33167
Landfill

MEMORANDUM

TO : Mark Witherspoon, Chief, Solid Waste Division
FROM : Tony Morris, Geologist Solid Waste Division YM
DATE : 5-APR-1990
SUBJECT : Groundwater monitoring at the Sunray sanitation landfills (Permit No. 162-SR1 and 123-SR1)

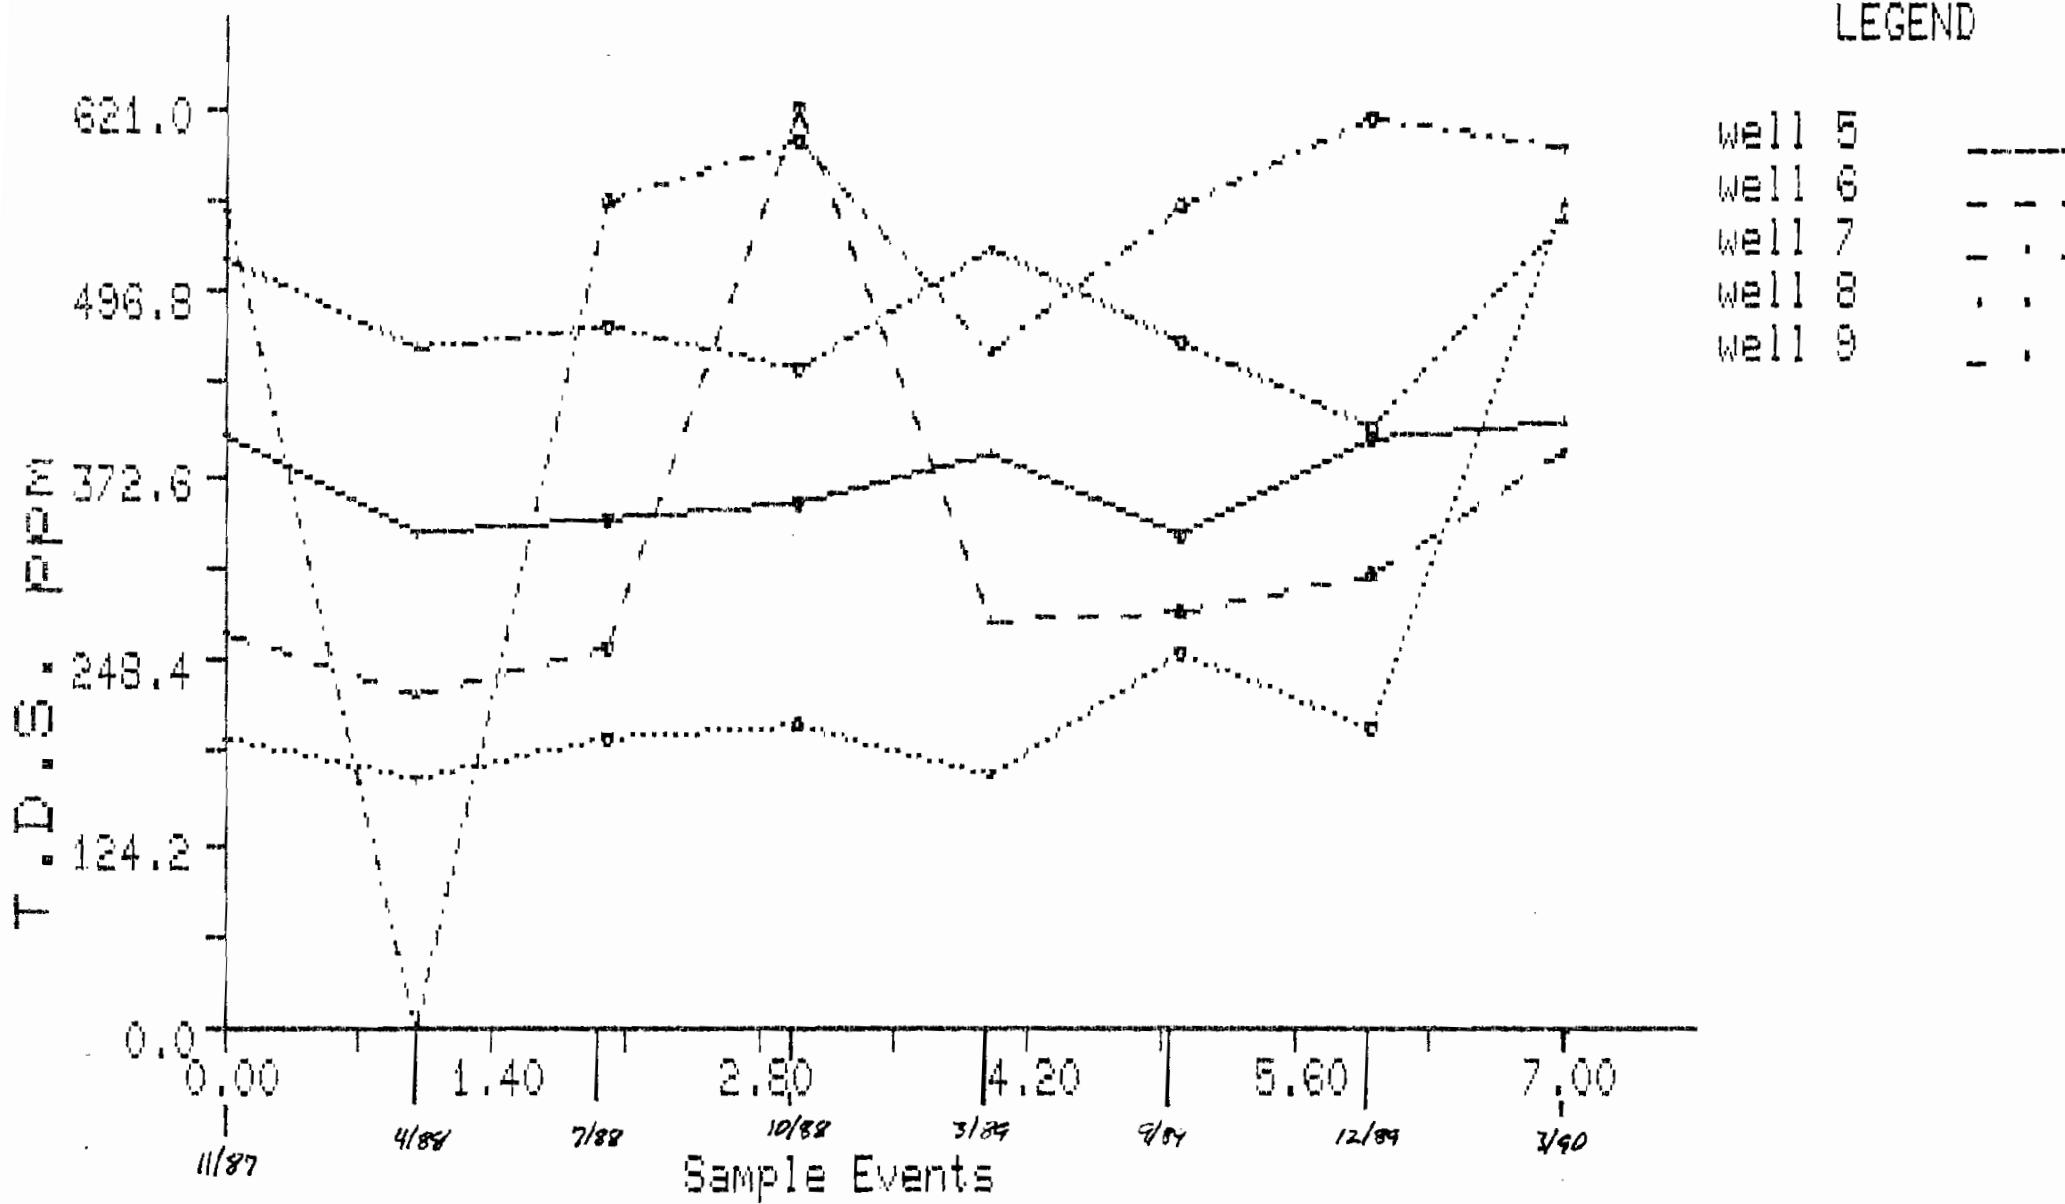
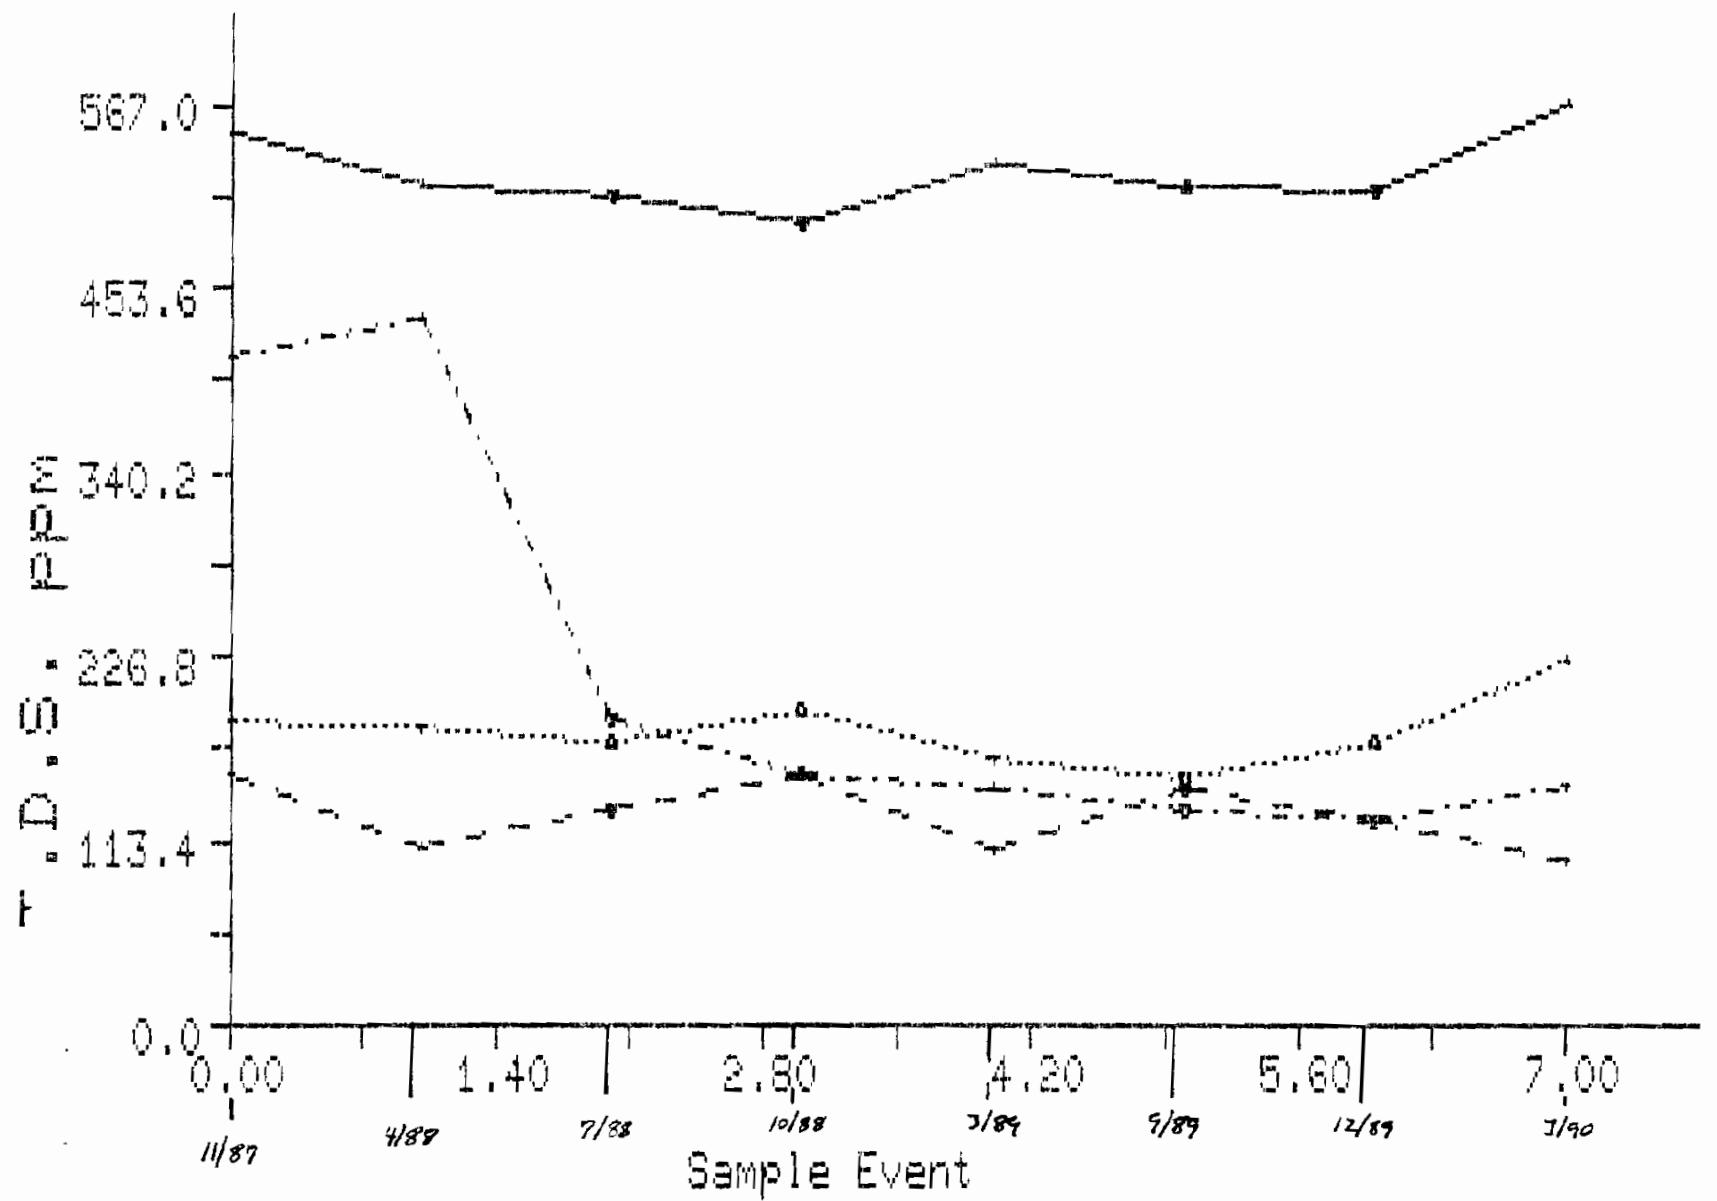
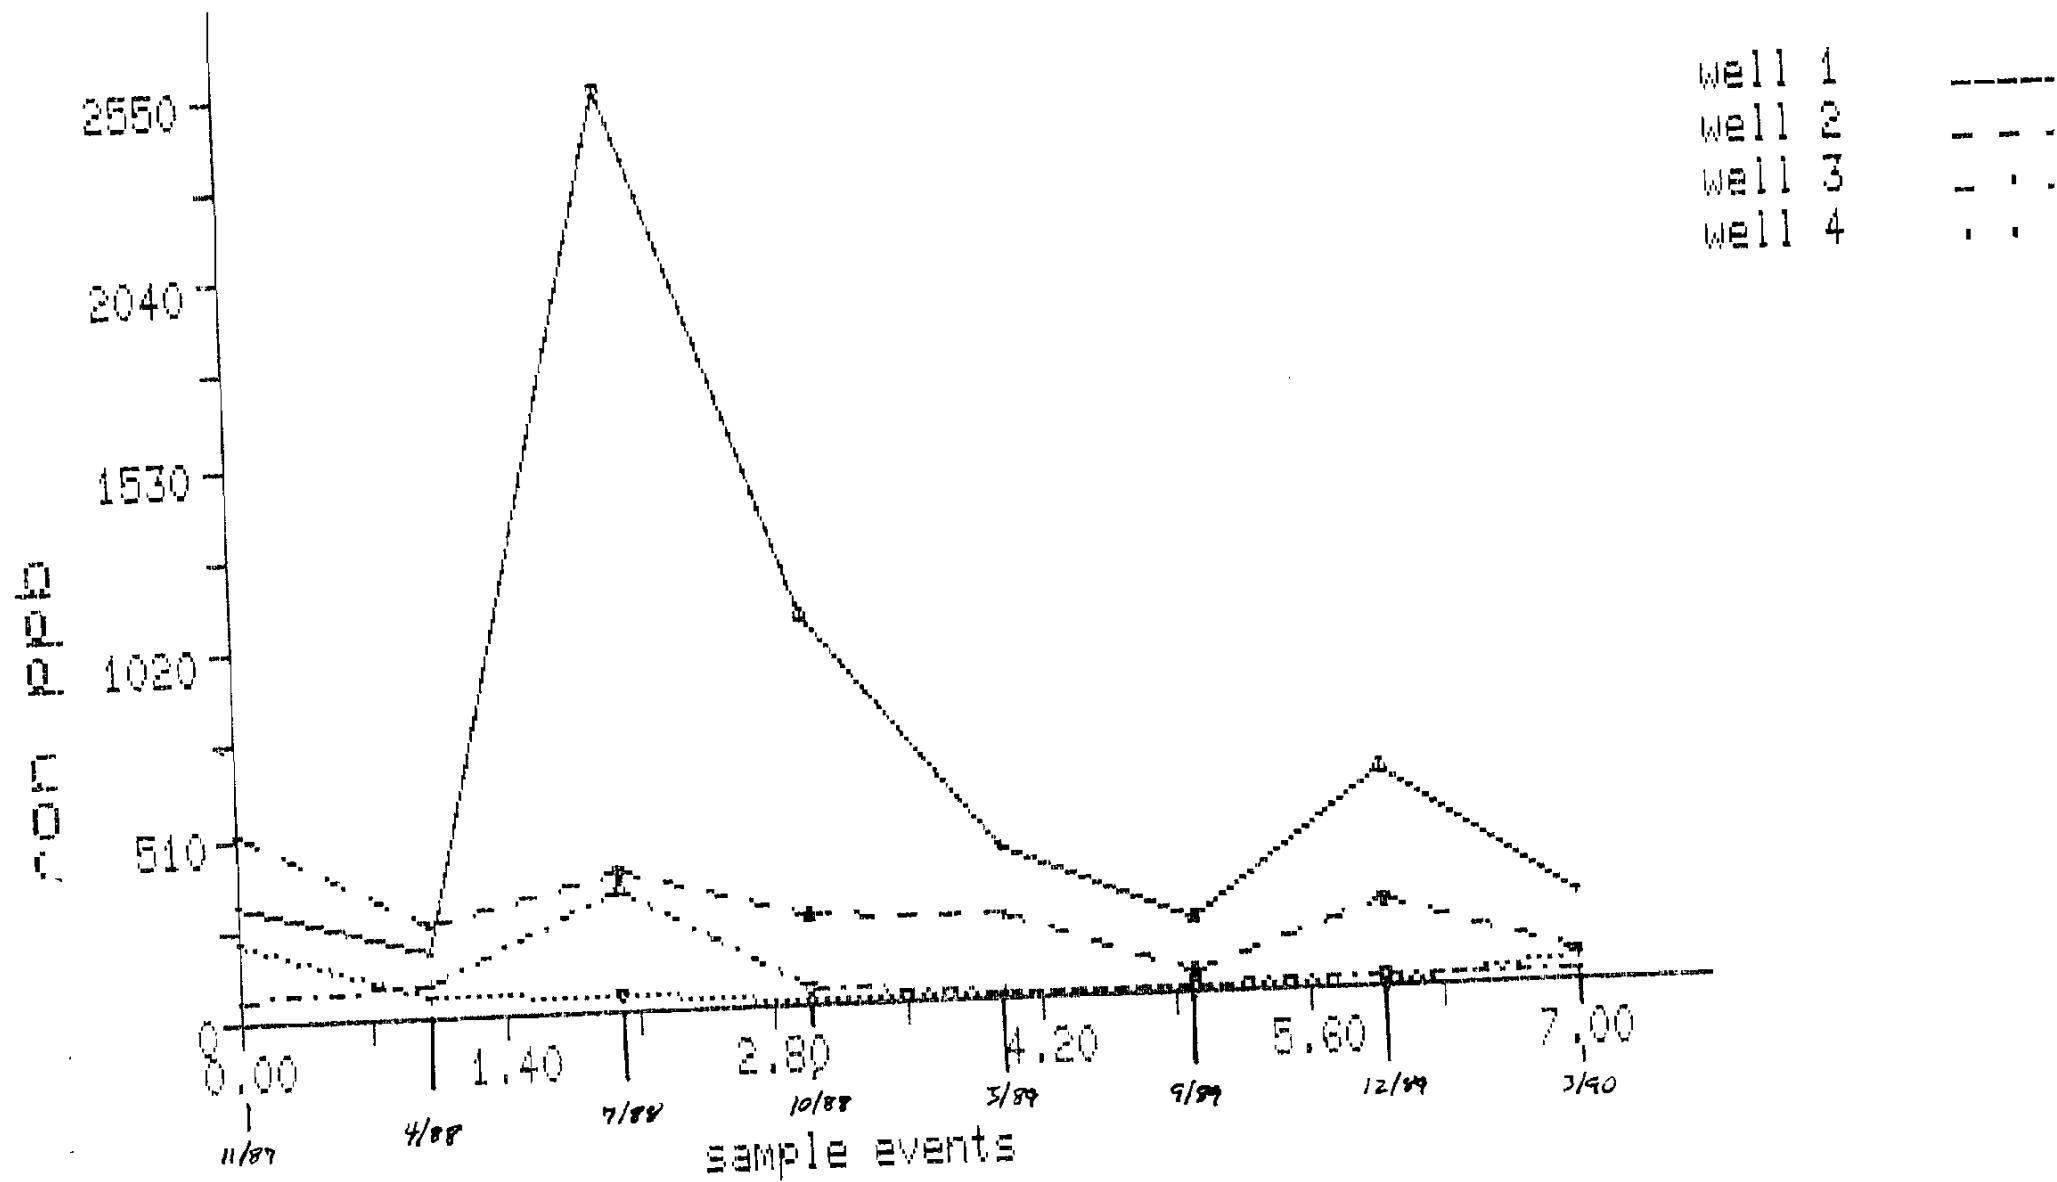
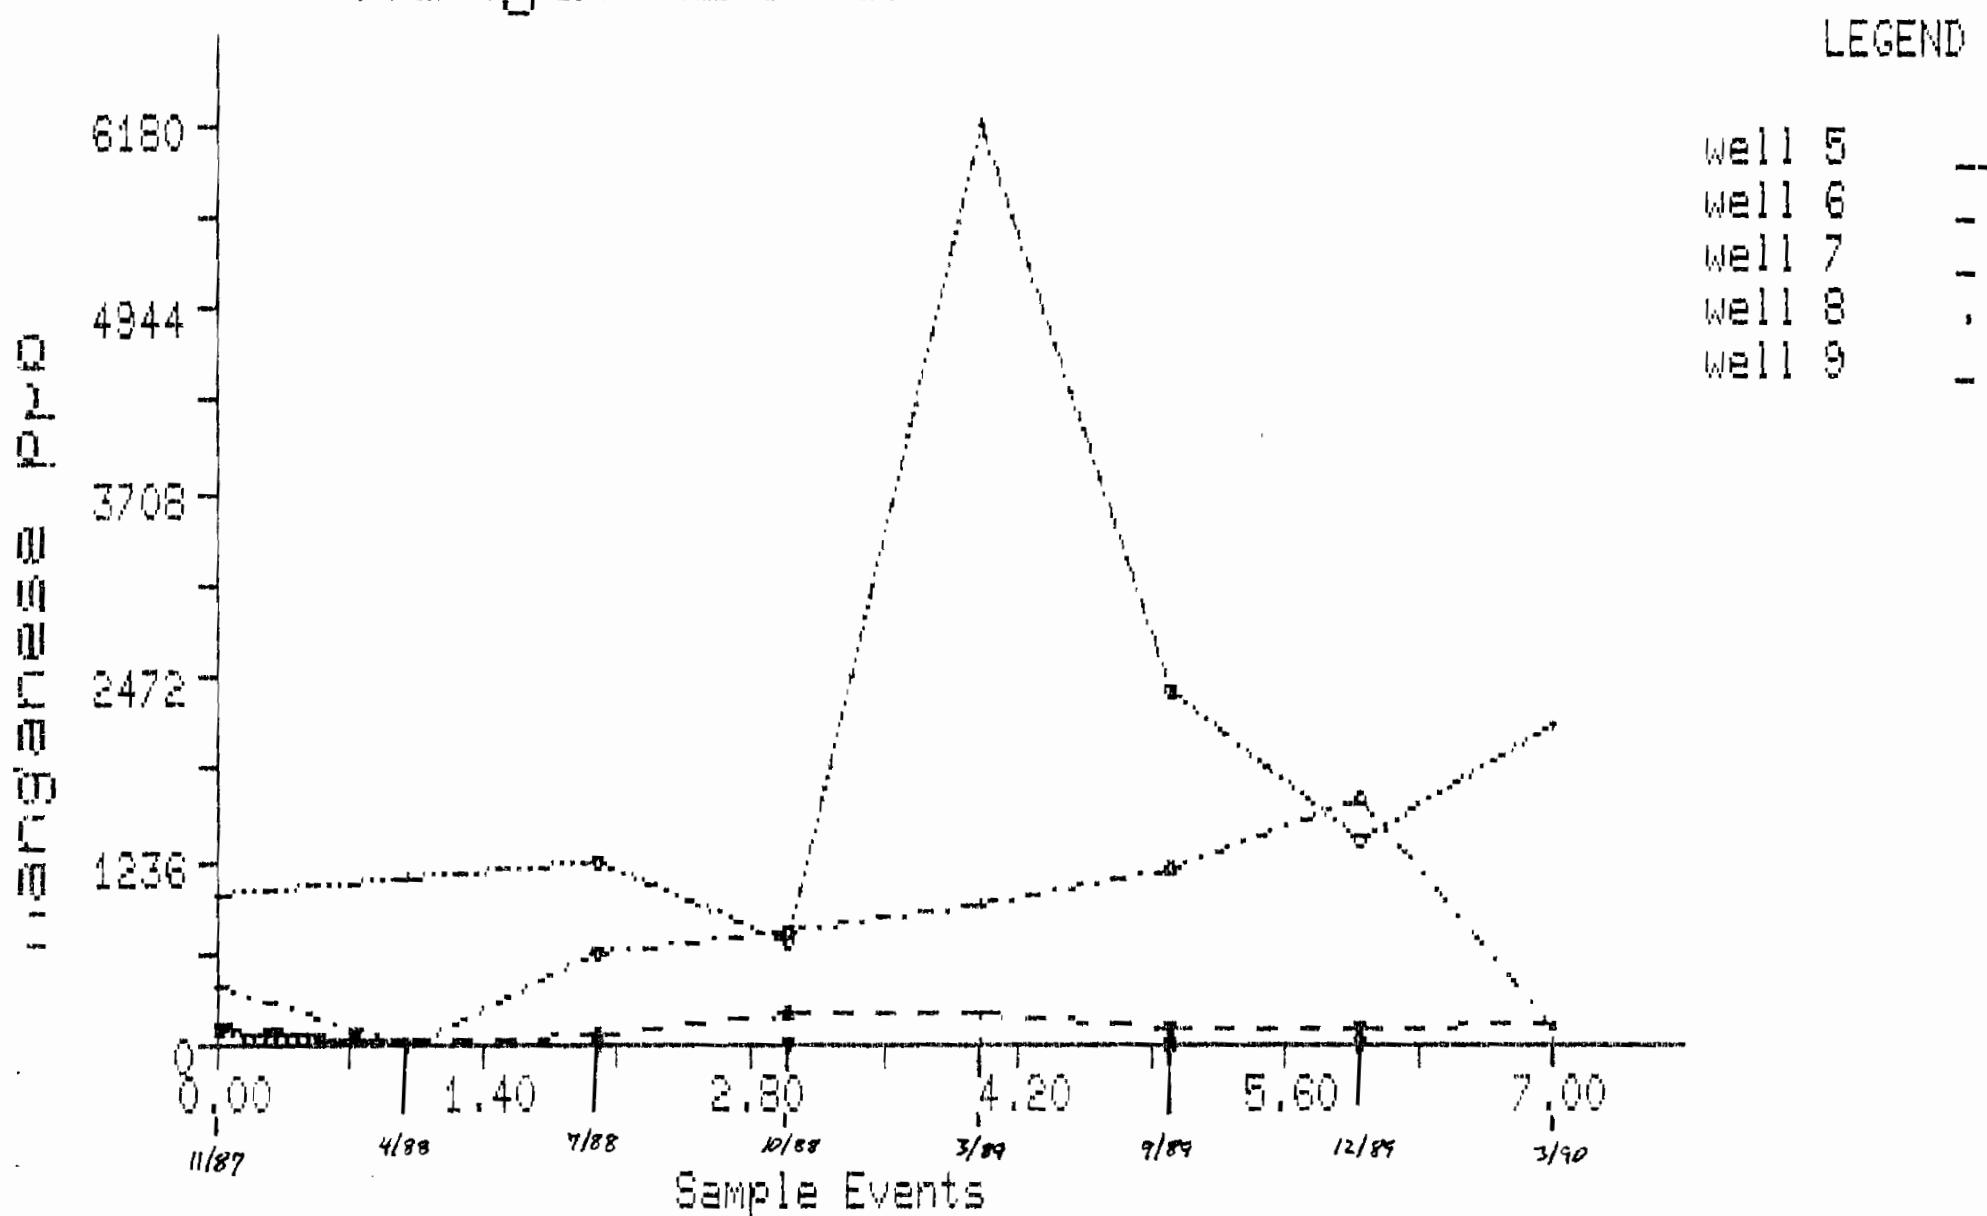
The data submitted thus far indicate the water quality between wells is much greater for each sampling event than would be expected for wells screened in the same hydrologic unit.

It is obvious from the data that several parameters exceed the National Secondary Drinking Water Standards in certain wells. Also, the last round of sampling at the facility indicated a positive detection of Methyl Ethyl Ketone in wells #7 and #9. This man made compound does not occur naturally in groundwater and is a constituent of a R.C.R.A. listed hazardous waste which was received by the facility on a regular basis prior to a 1986 legal action by the Department. Therefore, the positive detection can only be due to leakage from the landfill or laboratory error.

It would be appropriate at this time to require the facility to expand the list of parameters analysed for in the monitor well system. The list should include volatile and semi volatile compounds. The company should evaluate their sampling and analysis plan to insure the integrity of the reported values. It may be appropriate for the Solid Waste Division staff to split samples with the company at the next sampling event.
